SSD-10448-MOD2 – RESPONSE TO TRANSPORT FOR NSW COMMENTS

This letter is provided to the Department of Planning and Environment (DPE) in response to the Transport for NSW (TfNSW) comments received (TfNSW ref: SYD19/01350/46 dated 2 Sep 2022) for the Aspect Industrial Estate (AIE) SSD-10448-Mod 2 in relation to the design of the location of Warehouse 1 access driveway off Road 1.

Figure No.1 – Austroads Part 6 Warrants with Mod 2 Warehouse 1 and Road 1 'ultimate' traffic volumes.

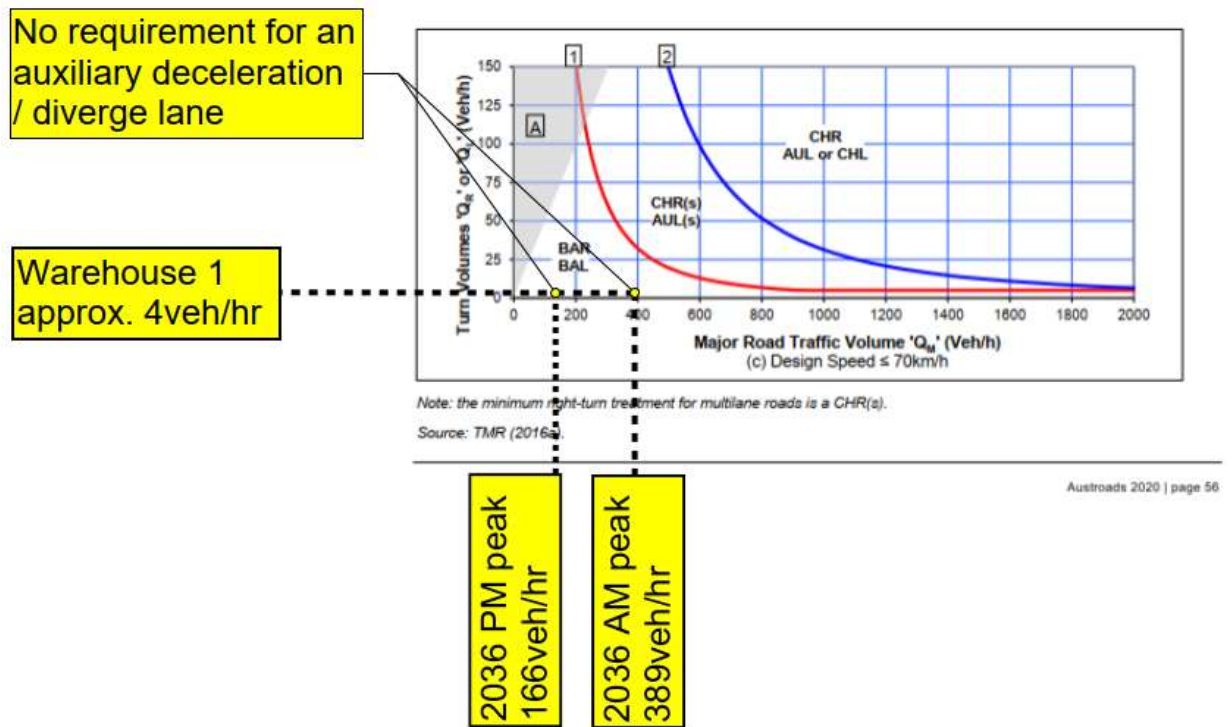
1. *TfNSW is concerned with the close proximity to the traffic signals and impacts to its safe and efficient operation. A heavy vehicle that uses the driveway will be approaching at a very low speed due to the size of the vehicle, short deceleration lane and high vehicle entry.*

With reference to the requirement for an auxiliary deceleration / diverge lane, review of the forecast Mod 2 Warehouse 1 traffic volumes that will utilise the Road 1 driveway and Austroads requirements indicates an auxiliary deceleration / diverge lane **is not required** for the Mod 2 Warehouse 1. The Road Safety Audit completed for the **revised Mod 2 Warehouse 1 driveway** arrangement (refer Appendix 3), is based on traffic volume information from Ason Group and the operational requirements of the customer for Warehouse 1 and notes the driveway is anticipated to experience traffic volumes of approximately 4 veh/hr during peak periods (1 vehicle maximum in a signal phase). The traffic network modelling underpinning the Mamre Road Precinct DCP forecasts 389 veh/hr in the AM peak and 166 veh/hr in the PM peak in the 'ultimate' scenario under a 2036 horizon travelling east bound of Road 1.

In contrast to the original Warehouse 1 approvals, Austroads Guide to Traffic Management – Part 6: Intersections, Interchanges and Crossings Management demonstrates that the forecast Mod 2 Warehouse 1 low volume of traffic and forecast ultimate east bound Road 1 traffic volumes **do not warrant** the provision of an auxiliary deceleration / diverge lane for Warehouse 1 (refer Figure 1 below). We note that AS2890.2: 2018 also does not require a deceleration lane for an access of this nature.

Extract from TfNSW drawing DS2015/003043[Rev C] showing a single right turn lane north to east.

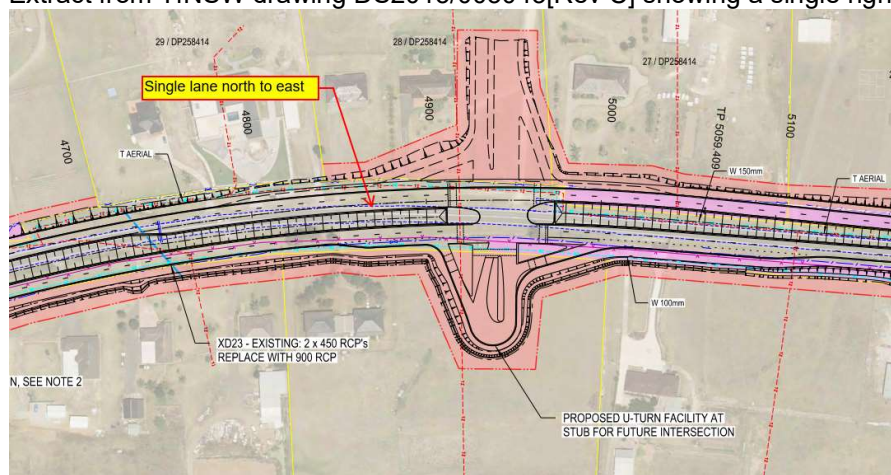
2. *The approved Mamre Road upgrade Stage 2 strategic plans indicate a dual right turn from Mamre Road into Access Road 1.*

Based on the information available, we believe this statement to be incorrect.

Please see below extract from the approved Mamre Road upgrade Stage 2 strategic plans as issued to Mirvac by TfNSW on 28 July 2020 for coordination and consideration as part of the Aspect Industrial Estate planning.
